**ADDRESS: 232 W. GRAND RIVER AVENUE (1410 WASHINGTON BOULEVARD)**

**APPLICATION NO: HDC2024-00231**

**HISTORIC DISTRICT: WASHINGTON BOULEVARD**

**SCOPE: INSTALL ENGRAVED STONE AT SOUTH FAÇADE STOREFRONT**

Detail from floor plan of new inset aluminum storefront approved by the Commission in 2017 for installation at the primary/south facade entrance

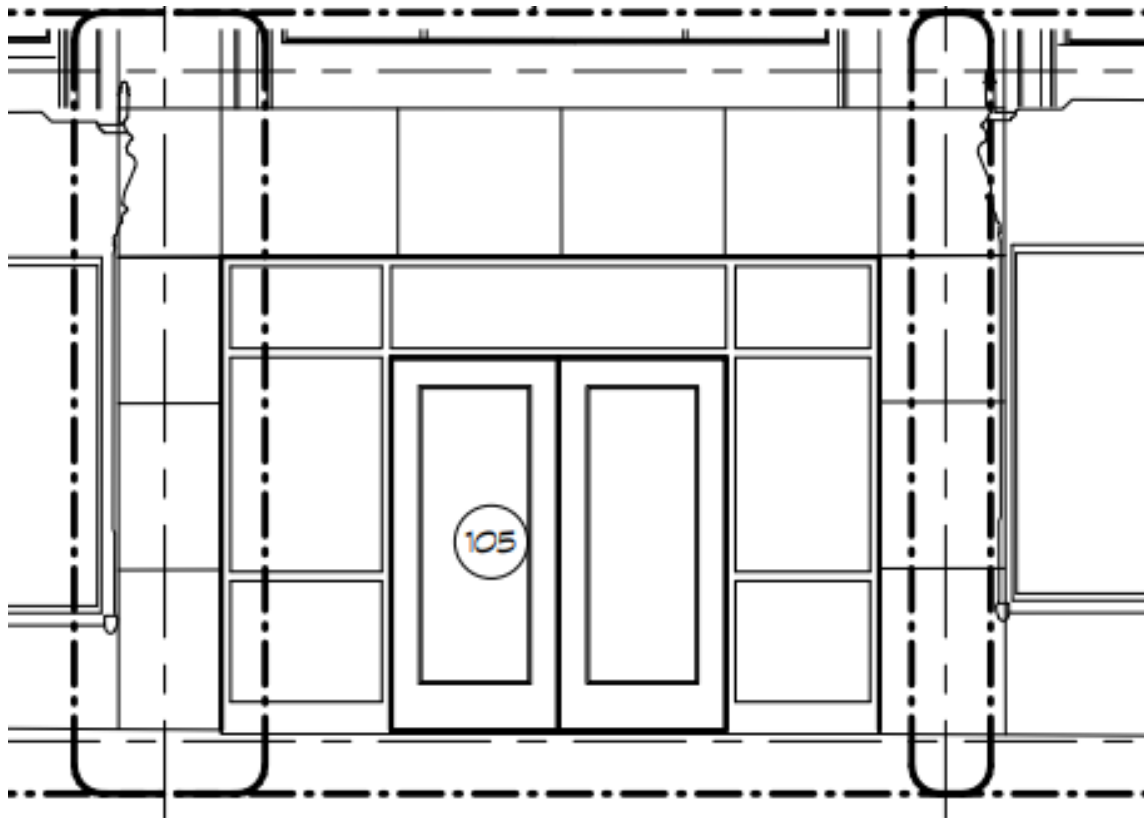
- In 2017, the HDC approved an application to rehabilitate the building's exterior to include the installation of new doors at the primary entrance and a repair of its surround. Note that the submission indicated that the surround was masonry. Specifically, the work item included the following per the below drawings and photo:
  - Remove the non-historic metal storefront and replace with a new aluminum storefront, which included a set of paired doors, a transom, and sidelites. The new storefront would be inset per the below plan.
  - Clean and seal the masonry door surround

- The 2017 drawings indicate that the doorway surround was “masonry.” The application notes that the masonry was clad with EIFS and was in poor condition. Also, the Commission’s 2017 approval did allow for the in-kind replacement of all deteriorated masonry where necessary. The new surround is limestone and generally appears to be compatible in appearance with the building’s historic character.

Elevation of new inset aluminum storefront approved by the Commission in 2017 for installation at the primary/south facade entrance.

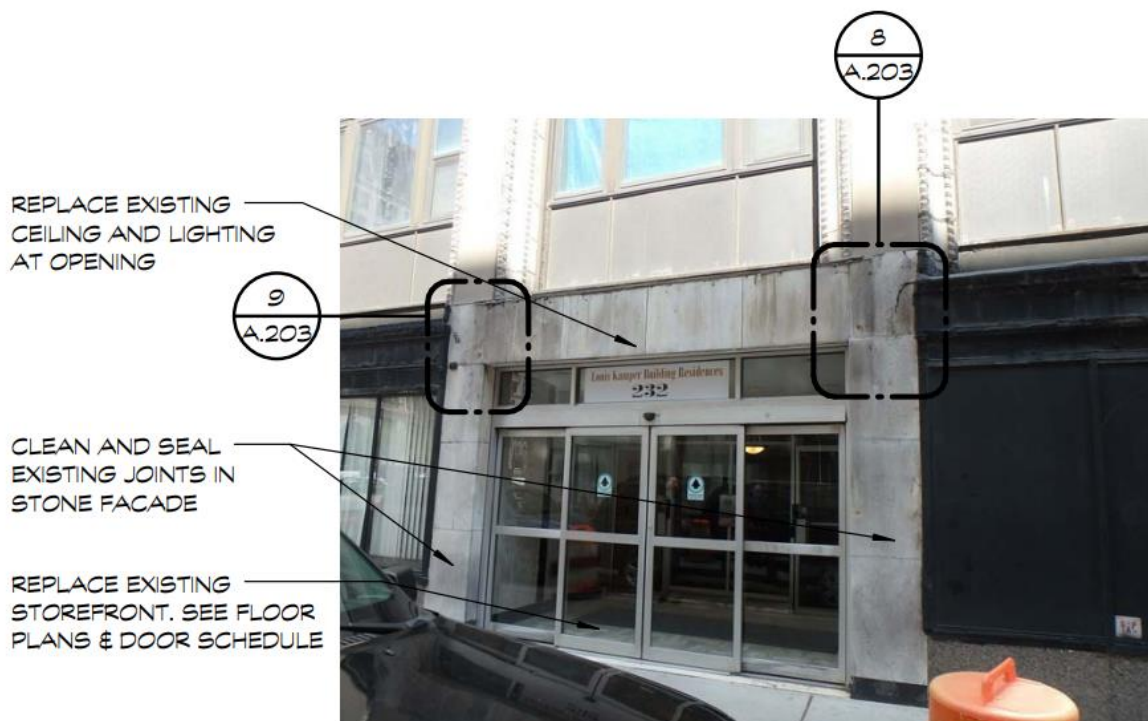
- After a review of the 2017 application materials and the current submission, staff supports the project for the following reasons:
  - In 2017, the Commission approved the replacement of the non-historic storefront doors with new aluminum storefront doors. The current storefront doors match those which were approved in 2017 and the storefront’s current location (flush with the façade) presents an appearance which is compatible with the building’s historic appearance and its other storefronts.
